**RE: RESPONSE TO COUNCIL REGARDING DEVELOPMENT APPLICATION AT
88 BOWER STREET, MANLY (DA2021/1400)**

Regarding the letter from Northern Beaches Council dated 24 January 2022, in relation to the Development Application for 88 Bower St, Manly (DA2021/1400), we have collated a response to address the items raised. The three items outlined in the letter were the classification of the building as alterations and additions work and the proposed breaches of the height and FSR controls.

Excerpt from DA-201, Elevations Sheet 1, issue B, Squillace Architects

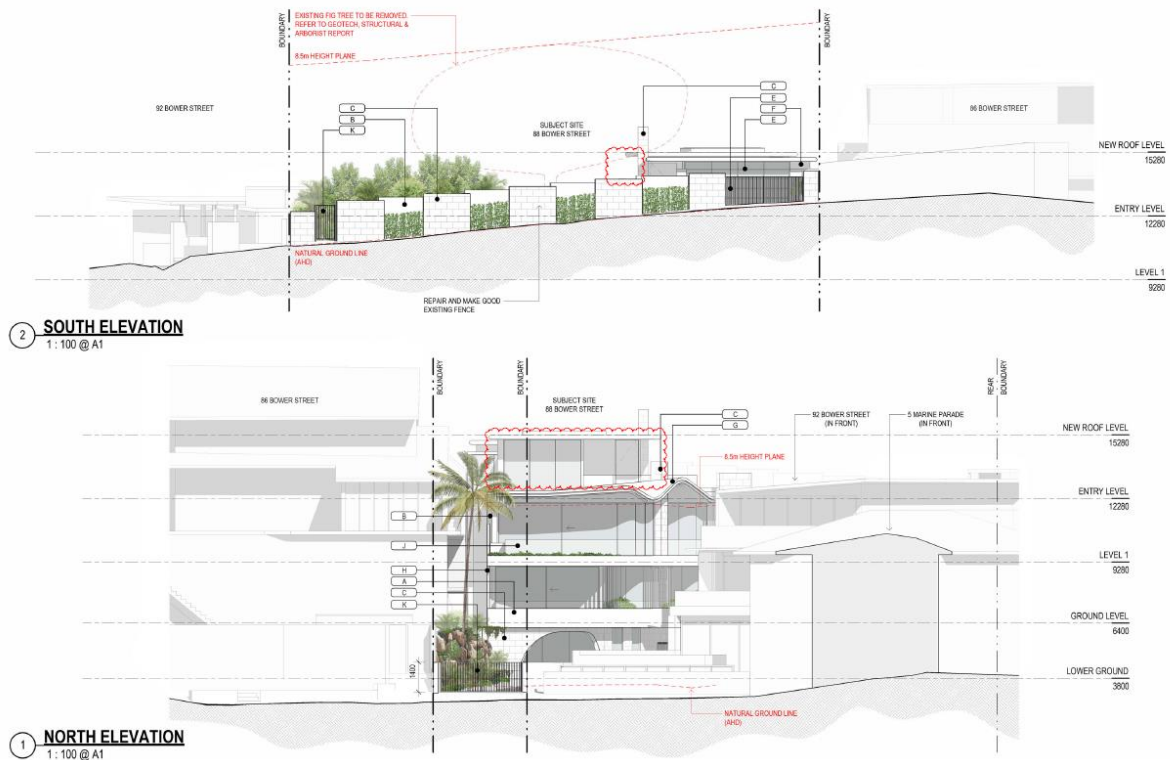
The application has not demonstrated consistency with the objectives of the building height development standard or that there are sufficient environmental planning grounds to justify contravention of the 8.5m height limit prescribed by clause 4.3 of MLEP 2013. The non-compliance is not consistent with the bulk and scale of surrounding development as suggested in the clause 4.6 submission, but rather as a result of the incorporation of four storeys in one vertical plane, elevated above existing ground level. The extent of non-compliance at Level 4 (Noted as entry level on the plans) is not supported.

When viewed from Bower St the proposal sits significantly lower than the existing neighbouring property to the east (86 Bower St) and at a similar (if not slightly lower) level to 92 Bower St to the west given the sloping topography as evidenced in the southern elevation. A similar condition occurs

at the northern elevation along Marine Parade which presents the proposal as consistent with the bulk and scale of the adjoining properties.

Excerpt from DA-201, Elevations Sheet 1, issue B, Squillace Architects

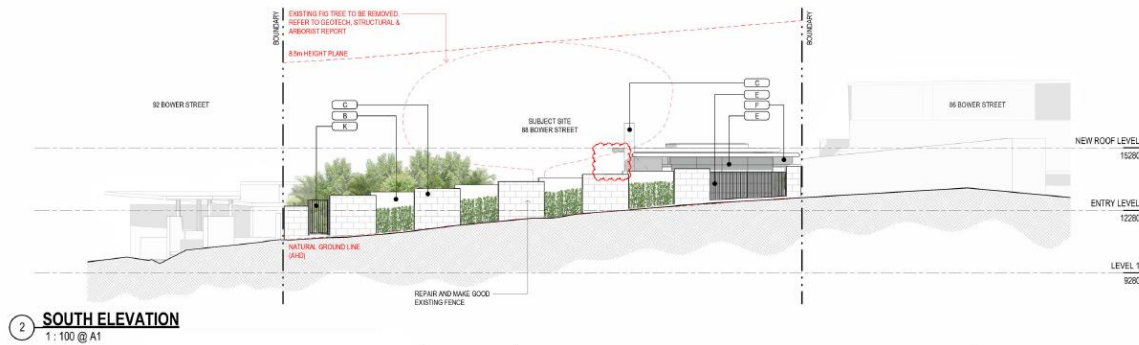
With a floor space ratio of 0.57:1, the proposed development exceeds the 0.45:1 floor space ratio prescribed by MLEP 2013. The application has not demonstrated that compliance with the FSR development standard is unreasonable or unnecessary, or that there are sufficient environmental planning grounds to justify the extent of non-compliance proposed, and as such, the proposed variation is not supported.

The proposed built form is sympathetic to the scale of neighbouring development and is comparable in scale and bulk to its neighbours as shown in the below elevation.

Photo of existing lower ground rooms that comprise of storage spaces given the constraints on uses, 02.02.22, Squillace Architects

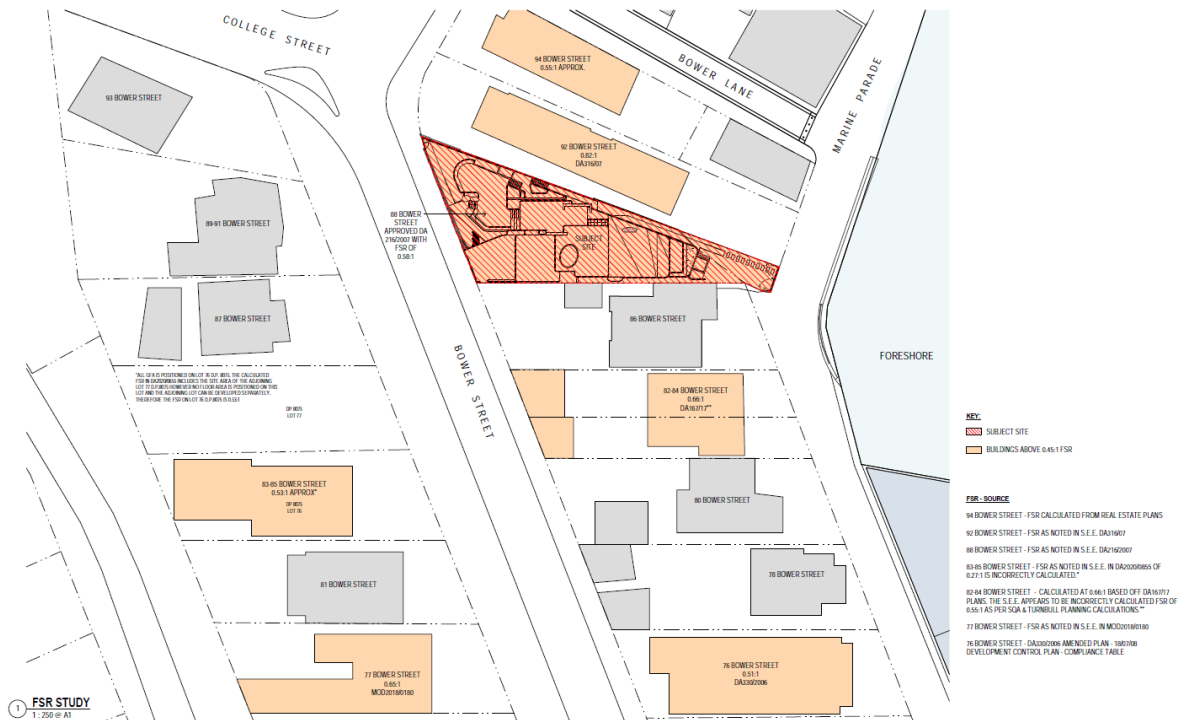
It is noted that the proposal has not incorporated a number of storage and access areas, into the gross floor calculations.

- The entire lower ground level is within an overland flow zone and subject to king tides and comprises of a significant portion of the GFA. Currently the existing lower ground floor RL of 3.8 sits below the flood planning level and associated freeboard requirements. As shown in the below site photography the lower ground is area is subject to water ingress during flood events, causing damp conditions, in particular within the lower portion of the walls, and significantly limiting the use;
- Given the above commentary regarding flood inundation at the lower level, the permitted gross floor area and FSR needs to be facilitated at the upper levels creating a breach of the height control. When this area is excluded the FSR of the development is 0.44:1 as noted above.
